**Re:** Railway (Metrolink - Estuary to Charlemont via Dublin Airport) Order [2022]  
Metrolink. Estuary through Swords, Dublin Airport, Ballymun, Glasnevin and City Centre to Charlemont, Co. Dublin

**Re: Railway (Metrolink-Estuary to Charlemont via Dublin Airport) Order 2022**

**Formal submission**

*View of existing access at Cross Guns basin*

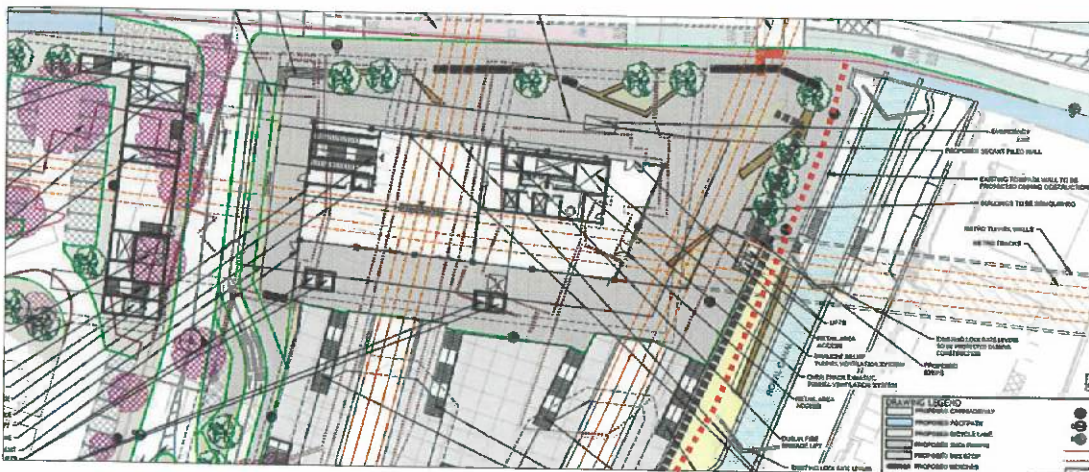
vehicles. In order to access their dwellings our clients are required to drive along the towpath for 840m from the access point on the north side of the Cross Guns Bridge. It appears that part of the our client access route will be altered as a result of the proposed Glasnevin Station and its associated ancillary surface level urban realm and landscaped area.

Excerpt from Drawing no. ML1-JAI-SRD-ROUT\_XX-DR-Y-02057 (Plan drawing no. ML-ST 304 N-01) indicating access to cottages in broken red line

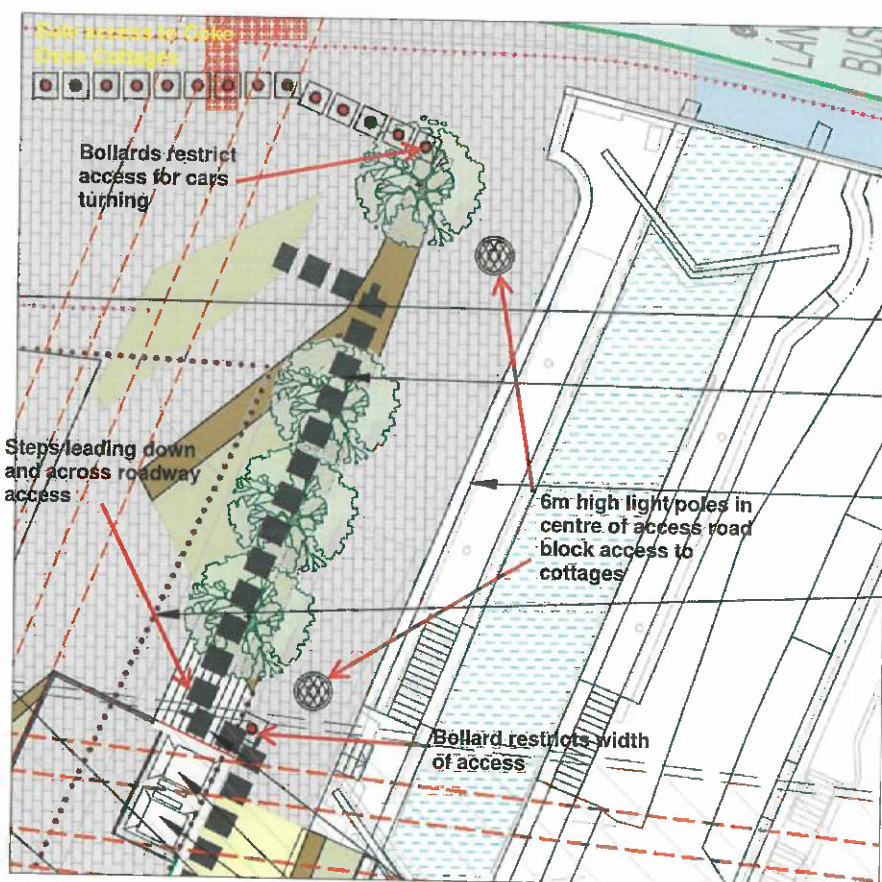
Our clients at Cove Oven Cottages have extremely serious concerns in relation to the operational phase of the proposed Metrolink at Glasnevin Station and the proposals in its immediate vicinity. Our clients would request that the applicant and An Bord Pleanála ensure the safeguarding of our client's access to their properties in a safe and sound manner. The current proposals appear to remove the vehicular access to their property; as well as creating pedestrian pathways across the access road along the towpath that would create a traffic conflict. The submitted surface level drawing of the Glasnevin Station indicates 2 no. 6m high lights located centrally within the access road to our clients' cottages.

The drawings provide a lack of clarity between the existing width of the towpath and the new towpath. Bollards along the main road also appear to restrict access for north travelling cars. The steps from the station concourse at street level that provides a connection to the canal will result in pedestrians blindly walking onto the access to the cottages, which is compounded by the position of the lifts abounding the steps and access road. This will result in a serious traffic and pedestrian conflict. The bollard on the road at the base of the steps will also further restrict our clients ability to access their property.

We respectfully submit that it is clear that currently our client's access arrangements are not being upheld. It is critical that both greater clarity is provided and design changes are made to ensure that their access is maintained without creating unrequired traffic conflicts. These changes should ensure the following:

- Ensure that the residents of Coke Oven Cottages have their full vehicular/pedestrian/cyclist access via the towpath roadway restored upon completion of the Glasnevin Station;
- Ensure that their right to turn left or right at the Cross Guns Bridge exit is restored after the Glasnevin Station works are completed; and
- Any proposed signage to be agreed relating to the 'Rights of Way to be Respected' relating to Coke Oven Cottages.
